**Hannah Weiser, Child Day Care Center, Conditional Use No. CU 2016-07**

**Staff Report Date: 4/29/16**

- Request for a Child Day Care Facility for 15 Children
- Address: 9205 Fernwood Road
- Zone: R-90
- Master Plan: 1990 Bethesda -Chevy Chase
- Applicant: Hannah Weiser
- Filing Date: November 13, 2015
- Public Hearing: June 3, 2016 at the Hearing Examiner’s Office.

Figure 8: Staff and Applicant’s Proposed Vehicular Circulation and Parking Plan

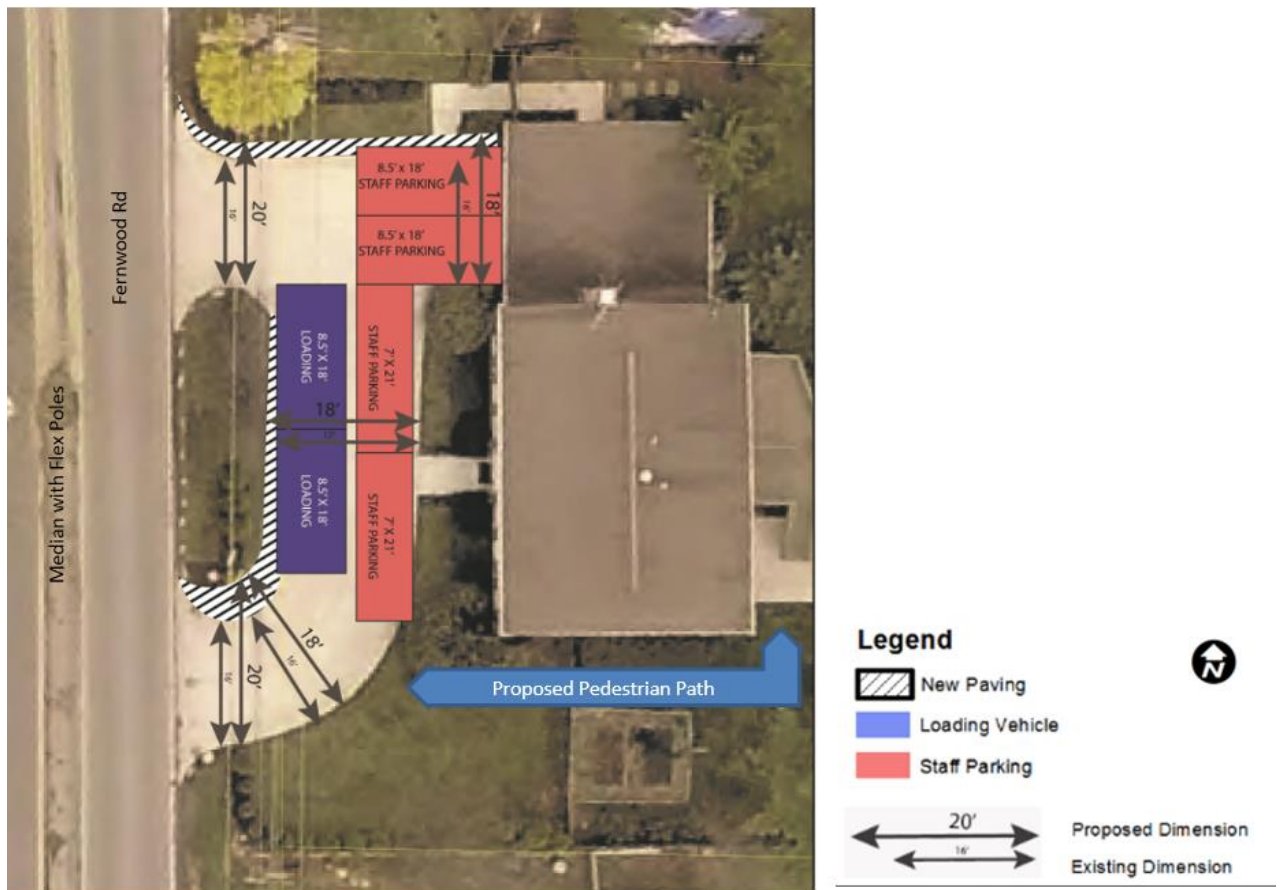
As shown in Figure 8, the semi-circular driveway and access points will be widened to accommodate on-site vehicular parking and circulation patterns. The semi-circular driveway will be signed for one-way traffic movement. Vehicles will enter the southern access point and exit at the northern access point. Four non-resident employee parking spaces are proposed on-site. Figure 8 shows employee parking in front of the garage and along the inner lane of the semi-circular driveway closest to the dwelling unit. Pick up and drop off areas for children will occur along the outer lane of the semi-circular driveway, closest to the road, shown in dark blue on Figure 8. This outer lane will also serve as short-term parking for parents to the site.

To accommodate the required parking and loading, Staff recommends that the applicant upgrade elements of the driveway to provide safe and adequate access and on-site circulation. The existing driveway access points must be upgraded to comply with the Montgomery County Code standard for commercial driveways. This improvement is necessary to accommodate new trips to the property.

12. The Applicant must upgrade the existing driveway as follows:
  - a. Widen both driveway access points to a standard 20-foot wide.
  - b. Widen the driveway, between the northern driveway access point and garage, to a minimum width of 18 feet to accommodate two standard (8.5' x 18') parallel parking spaces.

- c. Widen the semi-circular portion of the driveway to a minimum width of 18 feet to accommodate two seven-foot wide parallel parking spaces along the east side of the circular driveway and one 10-foot wide travel/ loading lane along western side of the driveway.

Figure 9: Existing Site Driveway Dimensions

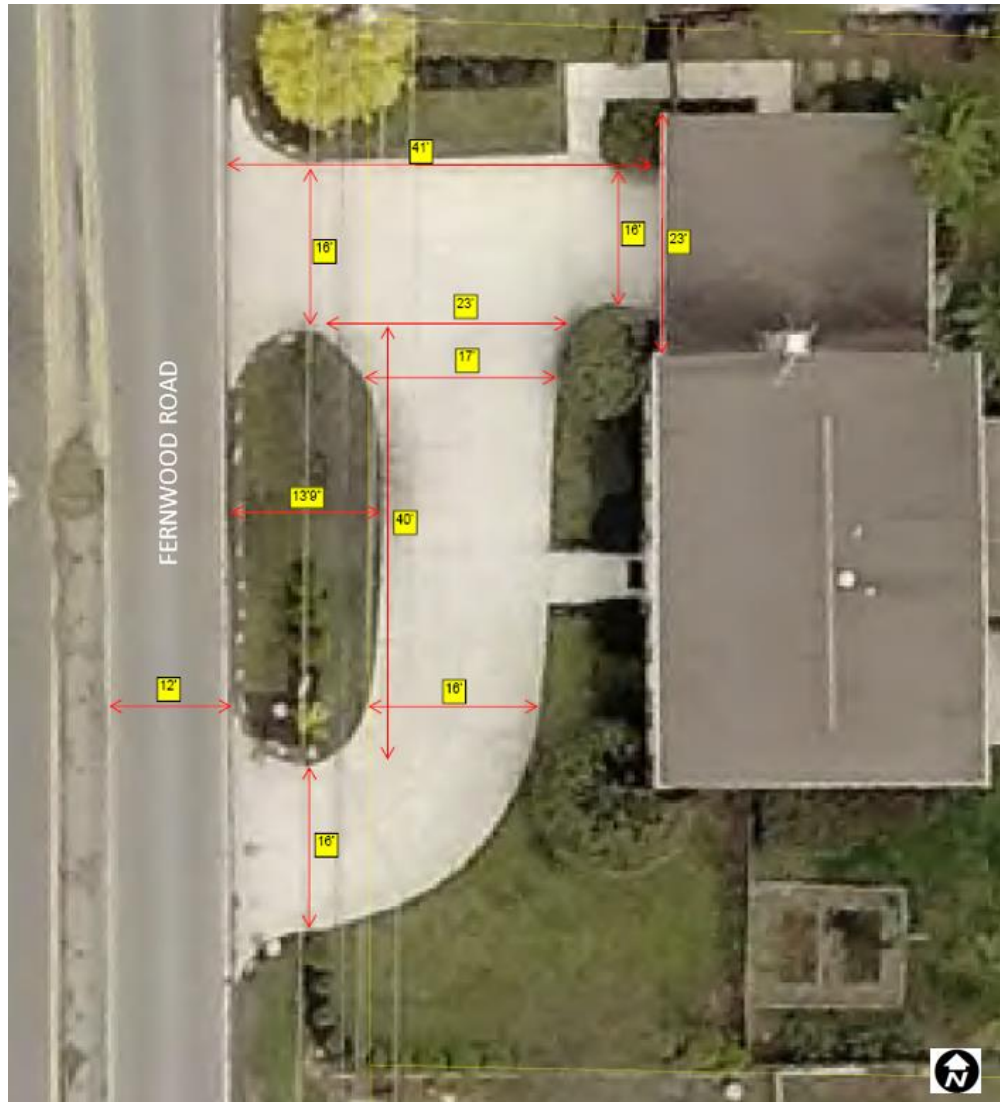
The site is improved with a semi-circular concrete driveway that has two access points on Fernwood Road. These access points connect on-site in a “u-shaped” configuration that allow vehicles to both enter and exit the site “head-first” without backing into the public roadway. Vehicular ability to enter and exit the site “head-first” is an important safety feature due to the proximity of the Fernwood and Greentree Roads intersection and the relatively heavy traffic volume on Fernwood Road along the site’s frontage. Due to the existing Fernwood Road median, the southern driveway apron currently functions as a right-in/ right-out access point for northbound Fernwood Road. The northern driveway apron currently functions as a full-movement access point for the dwelling unit. Dimensions for the existing driveway configuration are provided in Figure 9.

Figure 10: Staff Recommended On-site Vehicular Circulation Movements

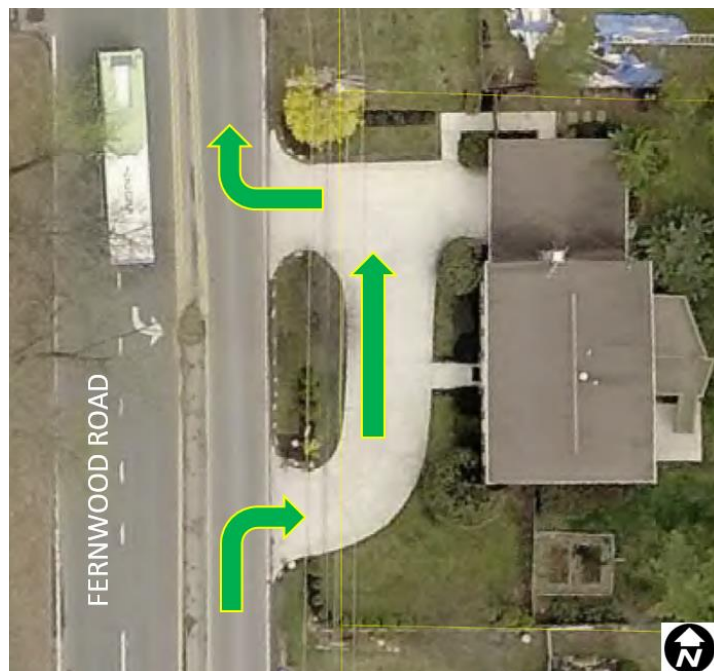
As a result of the site's proximity to the Fernwood Road/ Greentree Road intersection, Staff recommends that the driveway be restricted to one-way (counter-clockwise) movement as shown in Figure 10. This configuration requires all traffic to enter the site via the southern driveway entrance as an inbound right-turn only and exit the site via the northern driveway entrance as a right-turn movement. This configuration restricts all inbound site access at the northern driveway apron and effectively prohibits southbound left-turns from Fernwood Road into the site because of the existing median along this roadway. The access restriction and one-way internal driveway operation are necessary to mitigate the constrained nature of the site and respond to the traffic volume on Fernwood Road. Specifically, the recommended operations address the following:

- require all traffic to enter and exit the site "head-first," thus eliminating backing maneuvers onto Fernwood Road;
- eliminate potential conflicting maneuvers, at the northern access point, between entering and exiting vehicles;
- accommodate on-site parking; and
- promote safe on-site circulation.

13. The existing driveway must be signed and restricted to one-way (counter-clockwise movement) operation where traffic enters the site via the southern driveway entrance (inbound right-turn only) and exits the site via the northern driveway entrance (outbound right turn only). Driveway signage must be approved by the Montgomery County Department of Permitting Services.

Figure 2: Staff Recommended “One-Way” Access Pattern

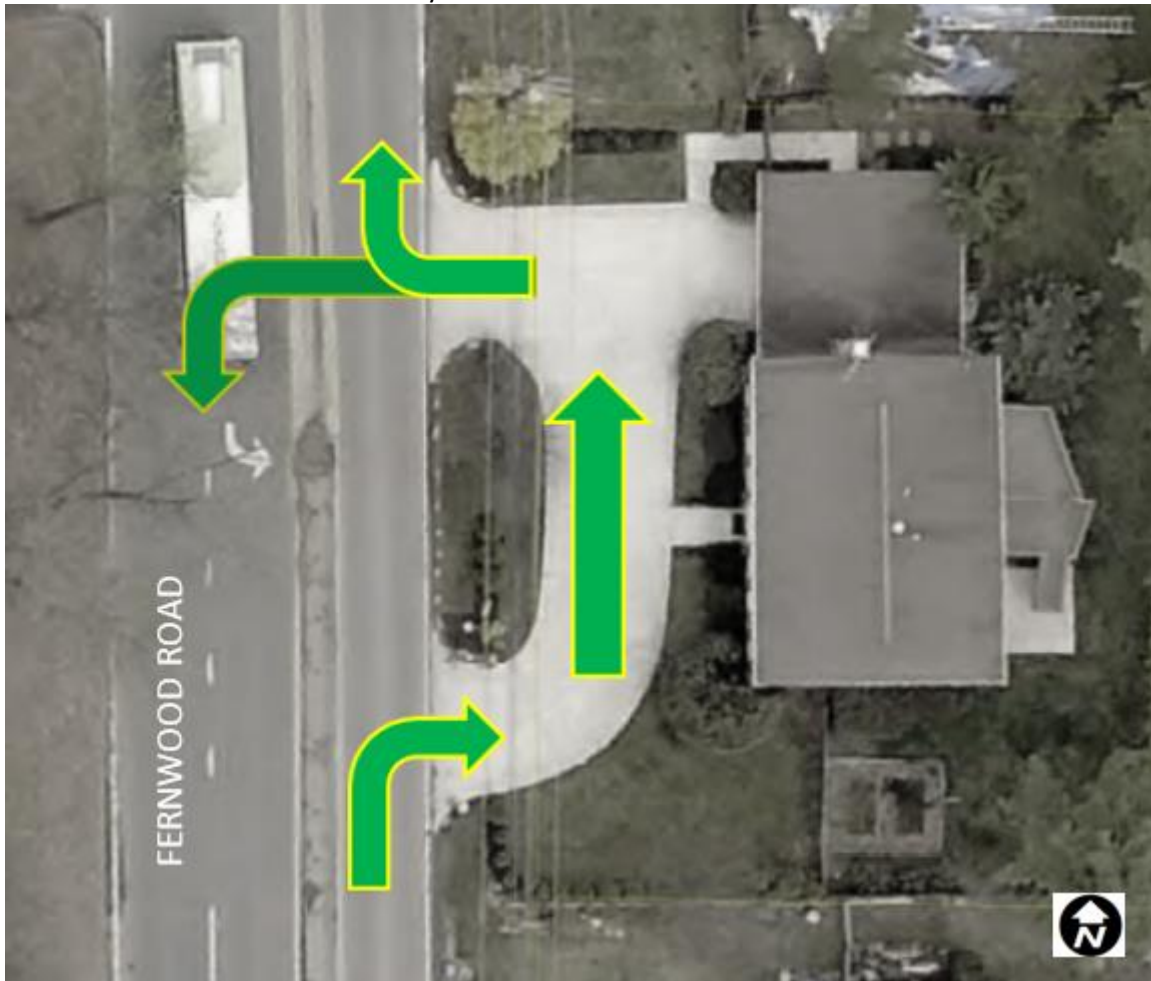
As a result of the site’s proximity to the Fernwood Road/ Greentree Road intersection, staff recommends that the driveway be restricted to one-way (counter-clockwise) operation (Figure 2). This configuration requires all traffic to enter the site via the southern driveway entrance (inbound right-turn only) and exit the site via the northern driveway entrance (outbound full movement). This configuration restricts all inbound site access at the northern driveway apron and effectively prohibits southbound left-turns into the site due to the existing median on Fernwood Road. These access restrictions and one-way internal driveway operation are necessary to mitigate the constrained nature of the site and respond to the traffic volume on Fernwood Road. Specifically, the recommended operations address the following:

- require all traffic to enter and exit the site “head-first,” thus eliminating backing-maneuvers onto Fernwood Road,
- eliminate potential conflicting maneuvers, at the northern access point, between entering and exiting vehicles,
- accommodate on-site parking,
- promote safe on-site circulation

Figure 3: Illustrative Site Parking Diagram

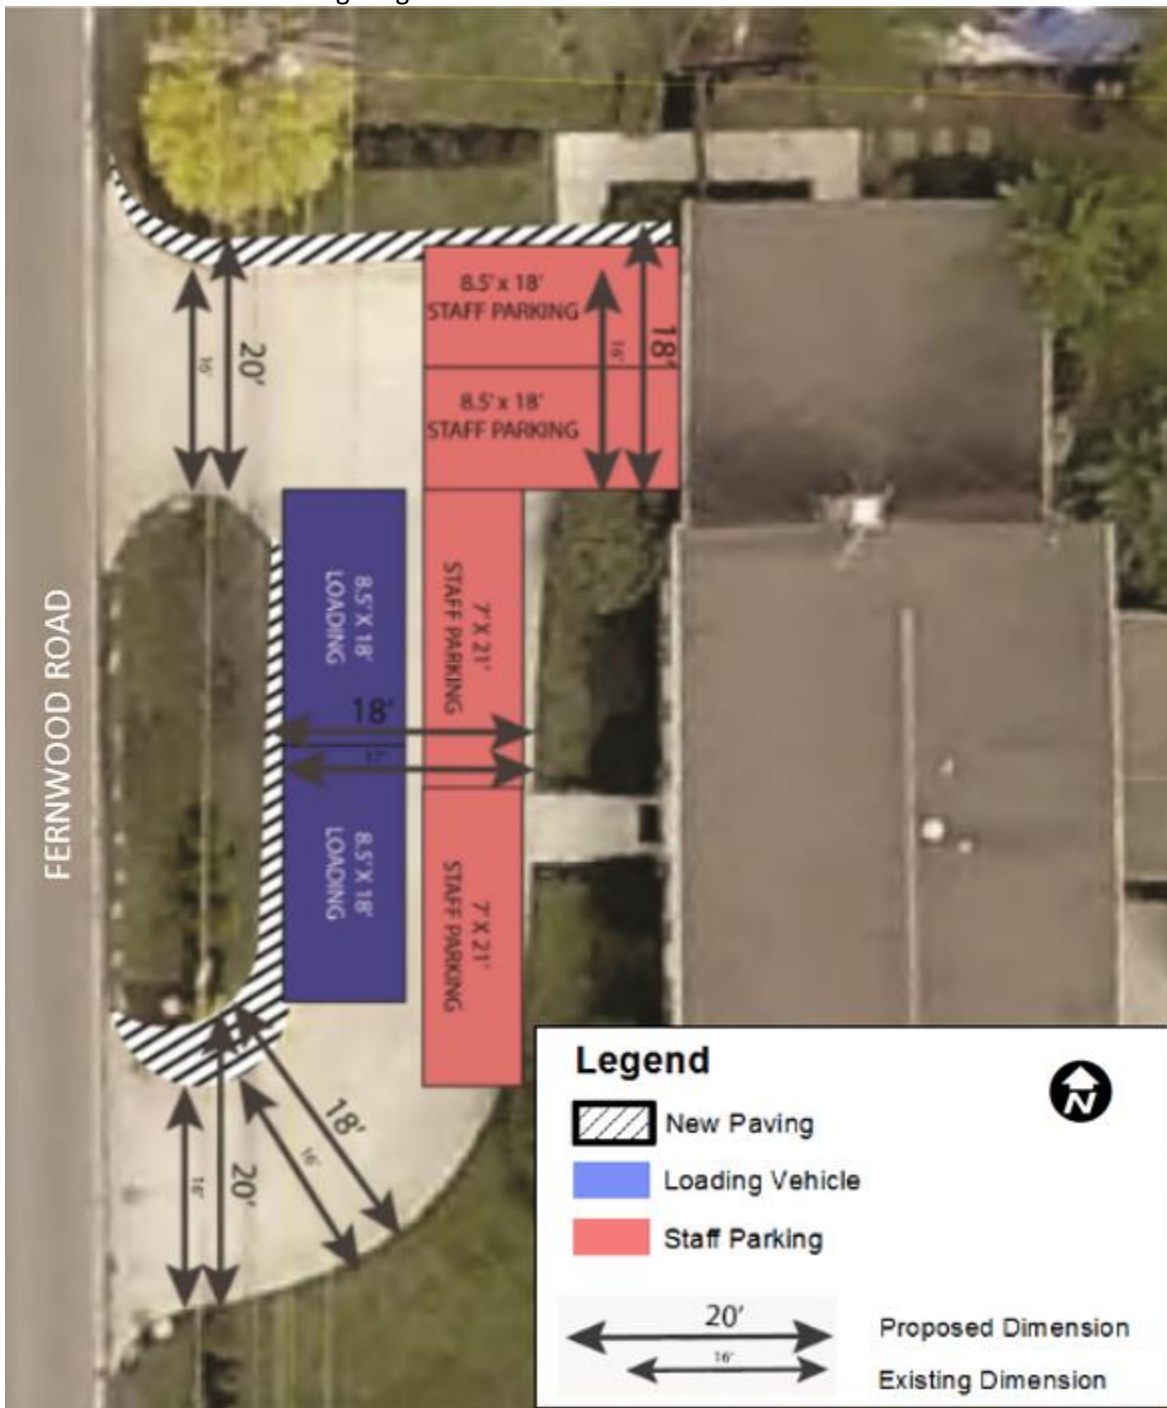
Under the most congested scenario described in the petitioner’s traffic statement, in which all employees are present and two parents are picking-up/ dropping-off children at a time, there will be six vehicles on-site. This scenario is demonstrated in Figure 3. As a result of the constrained nature of the site, staff recommends that the petitioner restrict the arrival of vehicles into separated arrival and departure groups such that no more than two parents arrive to pick-up/ drop-off children at a time and there are no more than six vehicles in the driveway at any given time. At full capacity, arrival/ departure groups could be structured as follows:

In order to accommodate the required parking and loading, as described in this memorandum, staff recommends that the petitioner upgrade elements of the driveway and site frontage to provide safe, adequate, and efficient access and circulation. Beginning with the public right-of-way, the petitioner should provide a five-foot wide public sidewalk along the entire site frontage and upgrade the existing driveway aprons to comply with the Montgomery County standard commercial driveway apron (MC 302.01). These improvements are necessary to safely convey pedestrians across the site frontage when the conditional use is in operation and to withstand the volume of non-residential traffic to the conditional

use. The petitioner should widen the on-site driveway to a minimum width of 18 feet to satisfy the Zoning Ordinance design requirements for drive aisles and parking spaces. This modification would provide the four requisite parking spaces as well as a 10-foot wide one-way drive aisle that could be used for on-site circulation and loading (parent pick-up/ drop-off). The parking spaces, loading spaces, and drive aisle should be clearly demarcated with pavement markings specified by the Department of Permitting Services. Staff notes that the constrained nature of this site precludes concurrent loading and circulation activities and necessitates pavement marking to ensure orderly on-site operations.

- e. Each individual parking and loading space must be clearly marked to provide for orderly and safe operation, as per Sec. 59.6.2.5.D.1 of the Zoning Ordinance.
